UNITED STATES  
DEPARTMENT OF THE INTERIOR  
BUREAU OF LAND MANAGEMENTFORM APPROVED  
OMB NO. 1004-0137  
Expires: January 31, 2018**SUNDRY NOTICES AND REPORTS ON WELLS**  
*Do not use this form for proposals to drill or to re-enter an abandoned well. Use form 3160-3 (APD) for such proposals.***SUBMIT IN TRIPLICATE - Other instructions on page 2**

**Revisions to Operator-Submitted EC Data for Sundry Notice #483353**

**PECOS DISTRICT  
DRILLING CONDITIONS OF APPROVAL**

**CO YETI 15 22 FED COM 0051H**

# BLOWOUT PREVENTER SCHEMATIC

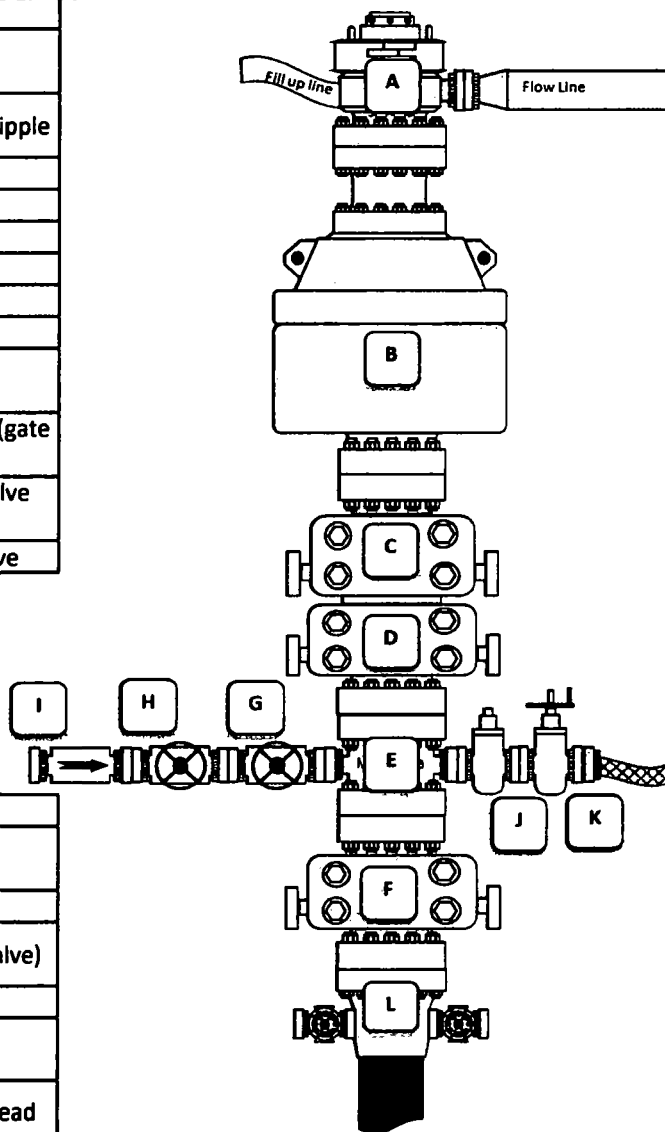
This sundry is to clarify the original COA's regarding pressure control equipment. The 5M BOP will be utilized on these wells after the surface shoe, and the 10M BOP (that is already included in the COAs) will be utilized after the intermediate shoe and therefore used for the production hole section accordingly.

See attached 5M Intermediate BOP and choke manifold

- a. Minimum working pressure of the blowout preventer (BOP) and related equipment (BOPE) required for drilling below the surface casing shoe shall be **5000 (5M)** psi.
- b. Minimum working pressure of the blowout preventer (BOP) and related equipment (BOPE) required for drilling below the intermediate casing shoe shall be **10,000 (10M)** psi.
